**Class II Permissive Change Cover Letter**  
**SUBJECT: Class II Permissive Change for FCC ID : VSOXR-150**

This is to request a Class II permissive change for FCC ID: VSOXR-150, originally granted on 09/15/2010.  
We changed the following points from the original model.

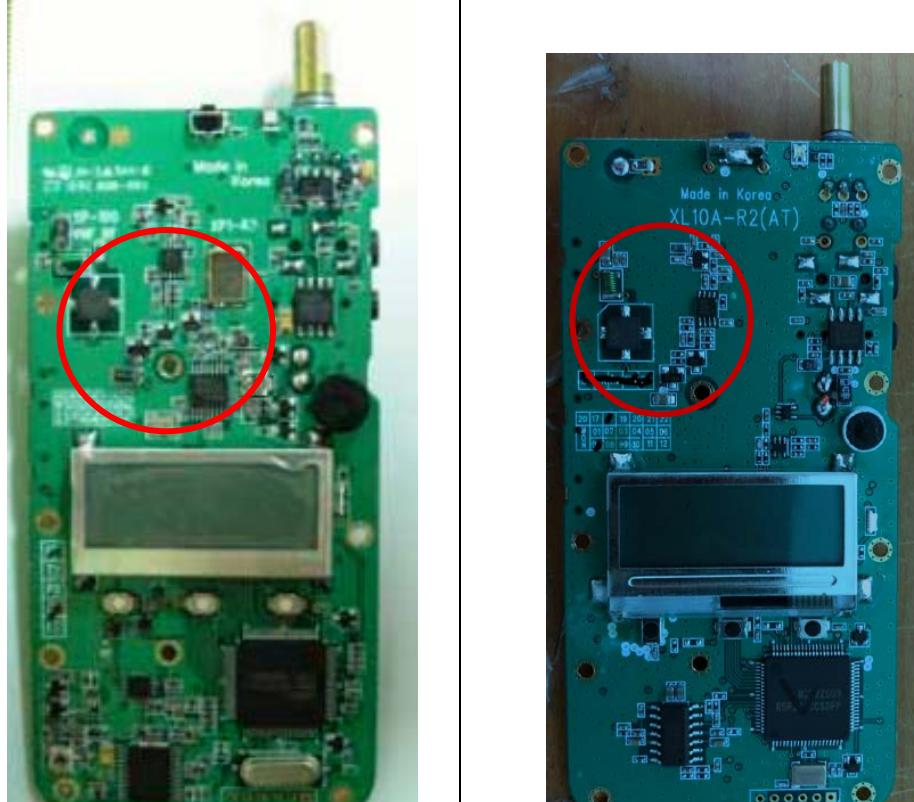
- Partial change of chips on the PCB board and single output due to software.  
(Using software, adjust the frequency to match Part90 and delete 25kHz from channel spacing 12.5kHz and 25kHz.  
In addition, we used 2W and 5W, but deleted 2W as a program and used only 5W.)
